Appendix – Main Modifications

West Berkshire Housing Site Allocations DPD

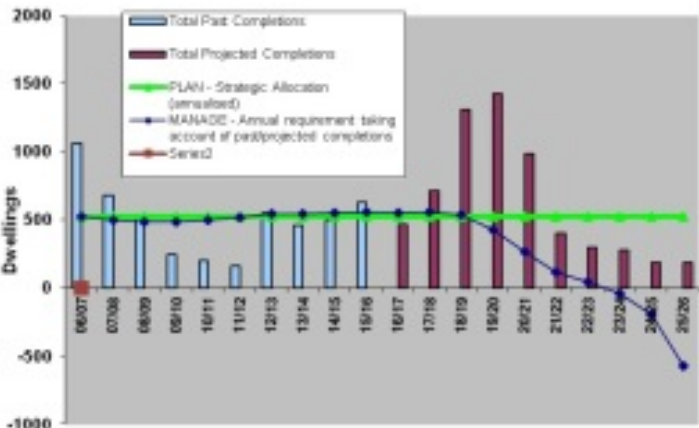
| Ref | Page | Policy/ Paragraph | Main Modification |
|-----|------|---------------------------------|--|
| | | | <p>THE009 Field between A340 and The Green, Theale HSA15 70 <u>100</u></p> <p>The figures in the trajectory have included a 10% discount for those sites with planning permission or identified through the prior approval process, where development had not commenced at March 2015/2016. The windfall allowance is applied up to 2020/21 for the whole District and only in the AONB in the last years of the plan period. The trajectory shows that the Core Strategy target is met over the plan period and that the DPD allocations will help meet the OAN up to 2022/23. There is flexibility in these numbers: there will be additional windfall and further identified sites which will enter the supply and the re-drawing of settlement boundaries will enable some additional smaller sites to come forward for development. The Council will be preparing the new Local Plan, with a new housing requirement, following work with our neighbouring authorities on how best to meet the objectively assessed needs identified in the SHMA <u>taking account of the planning constraints that apply.</u> This new Local Plan <u>will cover the period up to 2036 and will need to consider allocating new sites and to look again at the proposed housing distribution. and allocate new sites which will deliver in the later stages of the current plan period.</u></p> <p><i>Delete existing Housing Site Allocations Indicative Trajectory 2006-2026 table on page 110 and replace with the trajectory contained in Annex A (the final page) of the Housing Site Allocations DPD Schedule of Proposed Main Modifications (December 2016)</i></p> <p><i>Delete both existing charts on page 111 and replace with the following chart:</i></p>  |
